Internal referral responses

DA No. 5.2021.221.1

To undertake staged subdivision comprising 742 residential lots, 2 neighbourhood business lots, 1 residue lot (future residential), 14 public reserve lots and associated infrastructure, 45 new roads, road widening and road closures, bulk earthworks, essential services (water, sewer, power & telecommunications), stormwater management facilities, landscaping and environmental rehabilitation.

DEVELOPMENT APPLICATION REPORT APPROVALS REGISTER REPORT

Figure 1. Site Contamination - Septic Systems

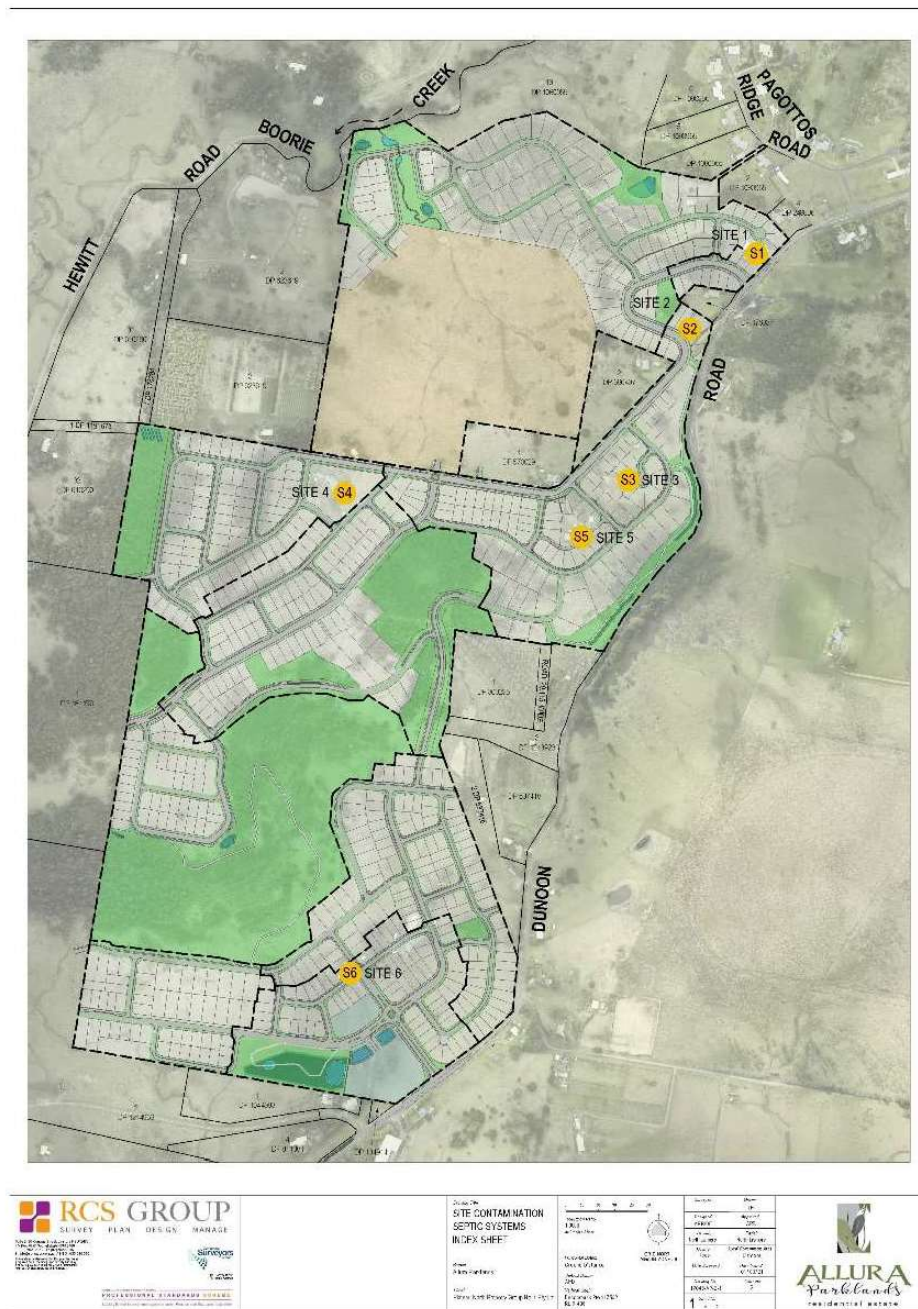
Additionally, you are required to provide information relating to the existing on-site sewage management systems (OSSM) that are proposed to be temporarily retained. This would be in the form of an OSSM report to address (at a minimum) Section 5.4.1(f) buffers to property boundaries in Council’s *On-Site Sewage and Wastewater Management Strategy*.”

No staging plan has been received with the additional information requested. Appropriate reporting is required so that existing on-site sewage management systems (including treatment device, pipe work and land application area) that encroach upon adjoining land as per Section 5.4.1(f) buffers to

property boundaries in Council's On-Site Sewage and Wastewater Management Strategy can be assessed and actioned appropriately.

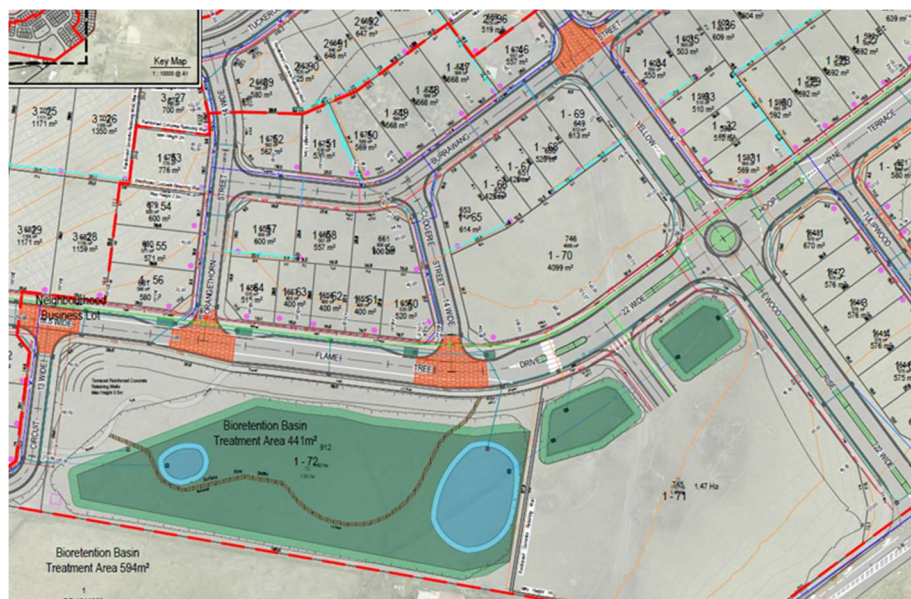
The proposed piped and bio pod treatment of waterway F in the southern precinct(s) is not a supported solution as it does not meet the Water Management Act and riparian corridor management objectives that seek to maintain environmental function of waterways.

- Existing watercourses are to be retained, and vegetated riparian corridors are established throughout the North Lismore Plateau site.
- Where authorised non riparian uses are proposed within the outer 50% of VRZ clear demonstration of the applied averaging rule must be provided as per “the Guidelines for riparian corridors on waterfront land” NSW Office of Water, July 2012
- Management of the Vegetated Riparian zones, storm water detention areas must be shown in the Vegetation Management plan as required by the DCP Chapter 10.

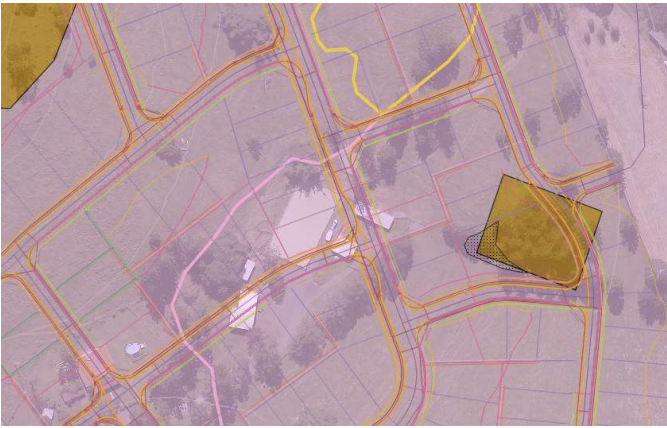
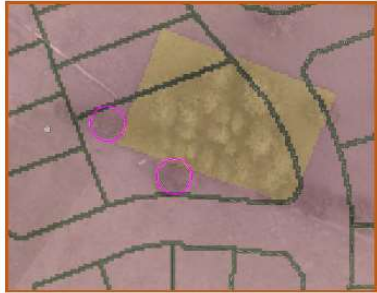
RFS Bush fire APZ's and perimeter tracks are proposed to occur on private property further detail is required enable determination.

- Both the VMP mapping and the Bushfire report must demonstrate (consistently with each other) that both the objectives are achieved. That is both inner and outer APZ not to be accommodated within reserves and C2 and C3 Zones.

Figure 4.2 Vegetation Zones, Plant Community Type (PCT), Vegetation Survey Plots and Zones with “r” are Retained and Zones with “C” are Cleared – All R1 zone is assumed Cleared/ impacted. (Source BDAR Greenloaning)

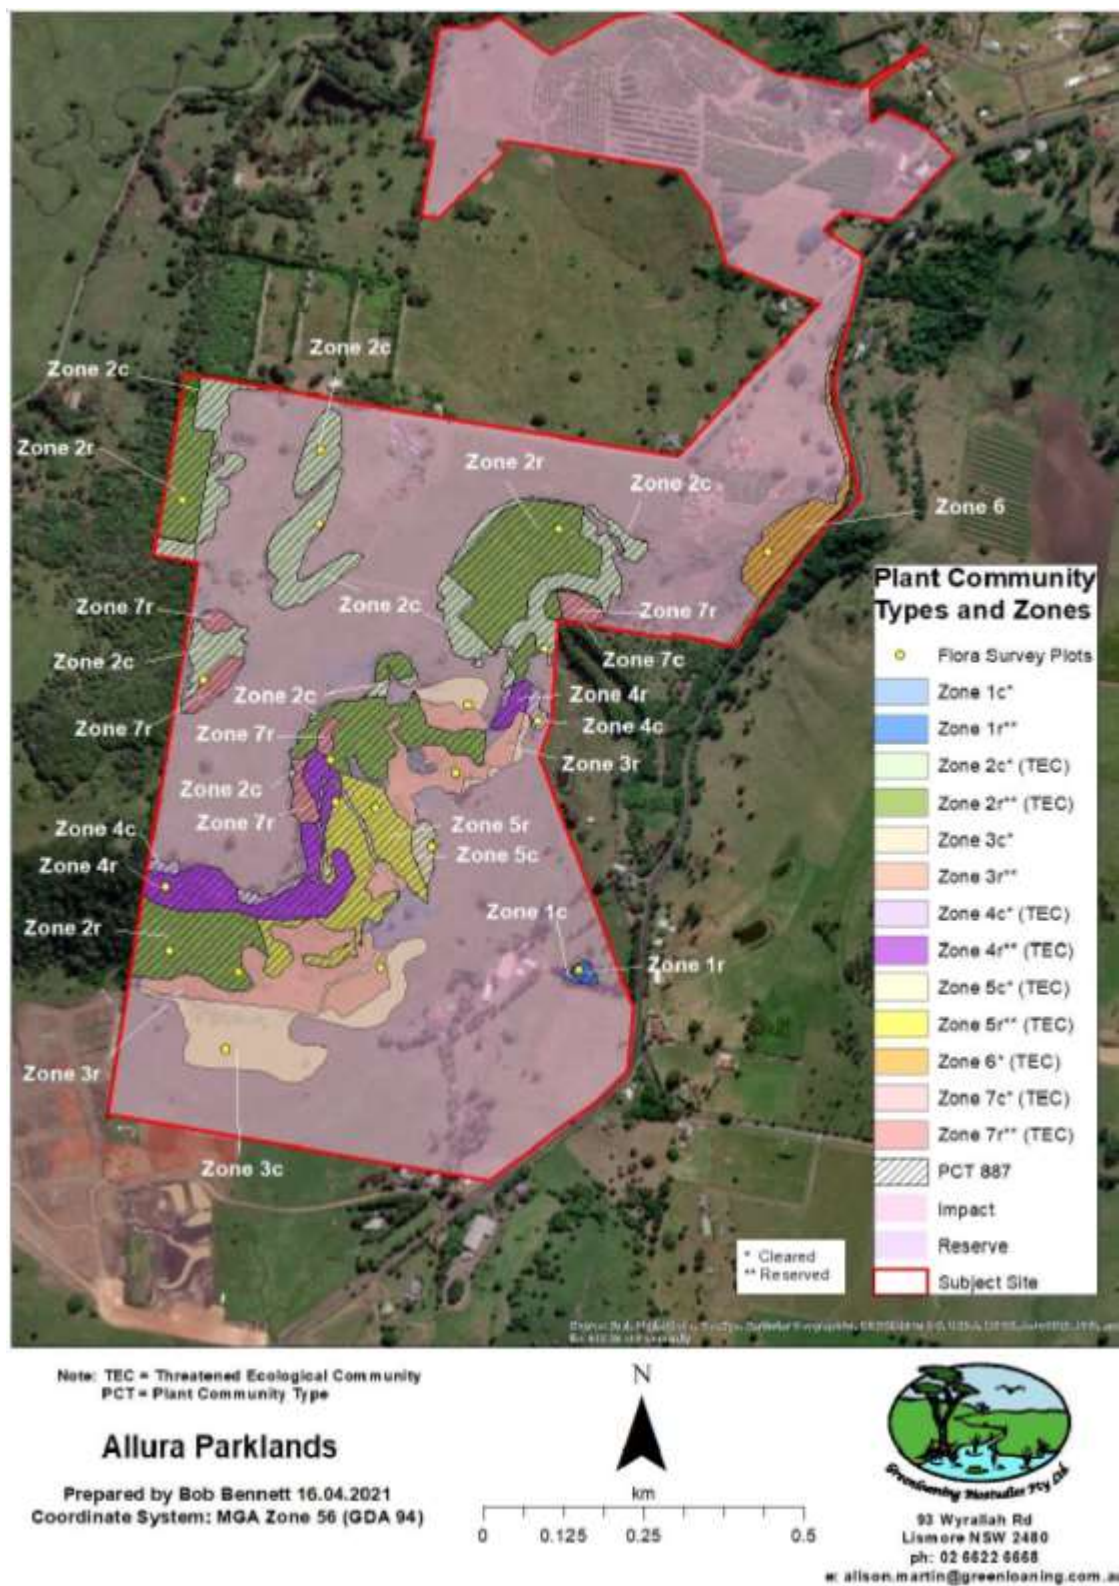
The matter of the design of Hoop Pine Reserve in Precinct 2 and impact on C2 zone is somewhat addressed – the submitted design provides for better retention of the existing Hoop Pine stand (unfortunately the result will be awkward mixed zoning). The Biodiversity Development Assessment Report data (left) shows the hoop pine patch (hatched) removed from the patch contrary to the rational (right) that the two hoop pines (circled in pink) would be retained. See Figure 4.2 in the BDAR

Subject to further detail it is assumed that only the native vegetation within the depicted Vegetation Management Zones will be retained (Source VMP AWC)

Figure: Extract from Revised Lot layout

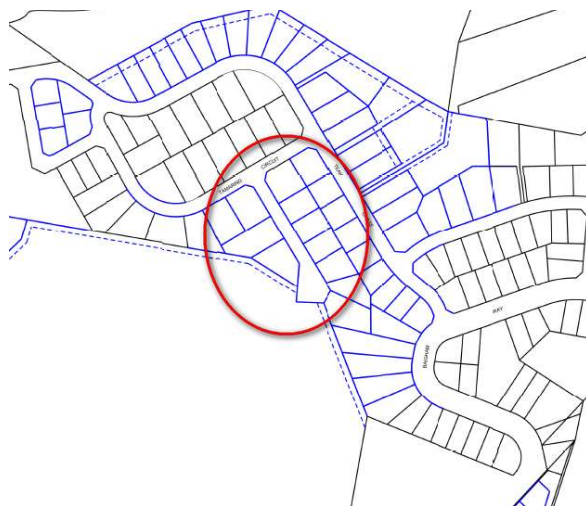
In response to a redesign request from the planner to remove a number of battle axe lots Council was provided with a plan titled Revised Lot Layout dated 8/6/2022, this plan showed for a road with a cul-de-sac (shown below) that had not previously been on an plan set. The only information is that the road has a grade of approximately 20% and is therefore non-compliant with the DCP. No additional details have been provided for the proposed road and therefore on that basis Council cannot support it.

Figure: Slope Risk Assessment from Geotechnical Assessment

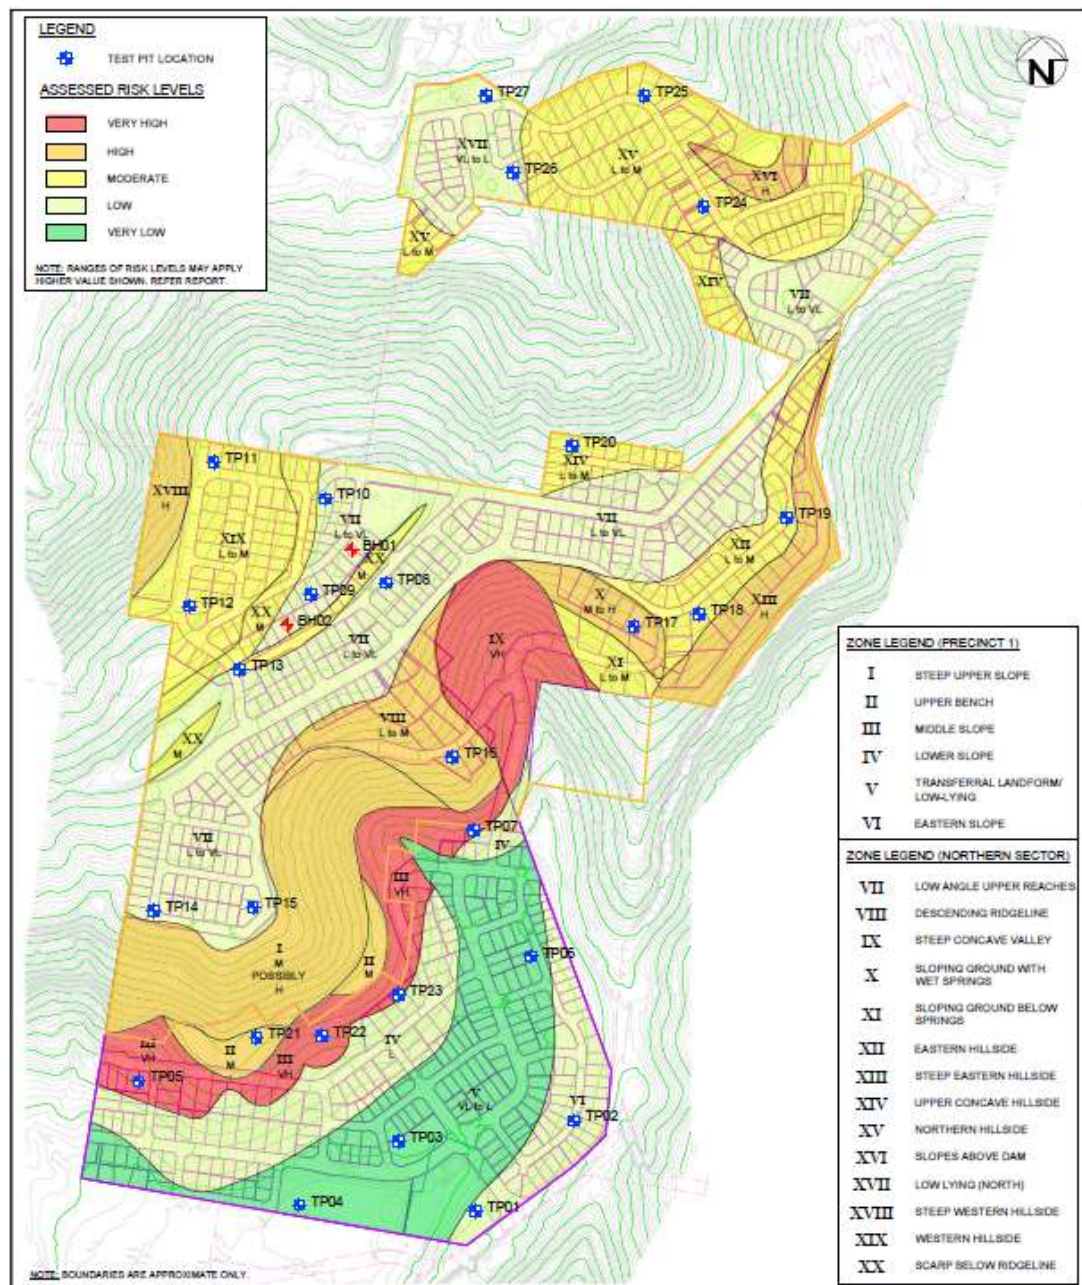
Review of the geotechnical report submitted with the DA raised some serious concerns relating to the areas shown as very high landslip risk, shown red on the map extract below. As the area is classed as very high landslip risk Council does not support residential development and infrastructure within this area. It must also be noted that this geotechnical assessment was not supplied during any pre-lodgement meetings otherwise Council would have raised this issue before the submission of the DA.

Council acknowledges that the geotechnical assessment does provide some options to reduce the risk of land slip however, this appears to only relate to “dwelling specific studies”. It is also noted that the proposed roads, being identified as Calistemon Parkway and Blackbean Way have non-compliant road grades, which is considered a dangerous situation in this location.

Additional information was requested to provide design details on how the very high landslip risk areas could be managed and utilised for the subdivision in a safe way.

- *Provide wholistic justification for the road/s traversing the areas highlighted in the Landslip Risk Map in red and marked IX VH. The Landslip Risk Assessment for Zone IX states “The assessed risk for Zone IX (Moderate to Very High) is not considered tolerable per Table 11.3, and will hence require specific engineering investigation and design advice for the development of the roadway. Any lots within this zone will need a detailed geotechnical*

- *Provide a detailed scope and design of the works required to reduce the risk level for any residential allotments or road infrastructure in Zone III and Zone IX. The scope and design shall also consider any areas of very high slope risk adjacent to the residential allotments or road infrastructure.*
